TRANS/WP.29/GRSG/61
16 July 2002

World Forum for Harmonization of Vehicle Regulations (WP.29)

Working Party on General Safety Provisions (GRSG)

REPORT OF THE WORKING PARTY ON GENERAL SAFETY PROVISIONS (GRSG)
ON ITS EIGHTY-SECOND SESSION

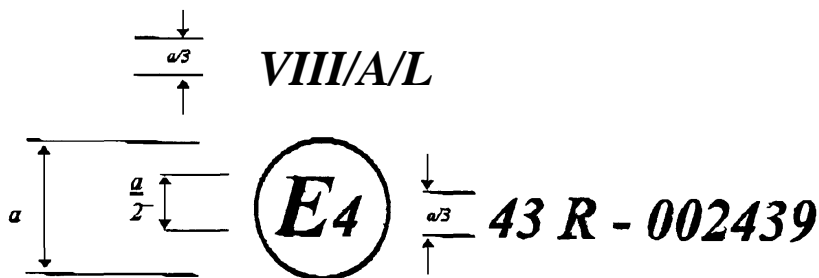
The example titled "Rigid plastic glazings other than windscreens", amend to read:

a = 8 mm min.

The above approval mark affixed to a rigid plastic glazing pane for forward facing panels with a light scatter not exceeding 2 per cent after 1000 cycles on the outer surface and 4 per cent after 100 cycles on the inner surface shows that the component concerned has been approved in the Netherlands (E 4) pursuant to Regulation No. 43 under approval No. 002439. The approval number indicates that the approval was granted in accordance with the requirements of Regulation No. 43."
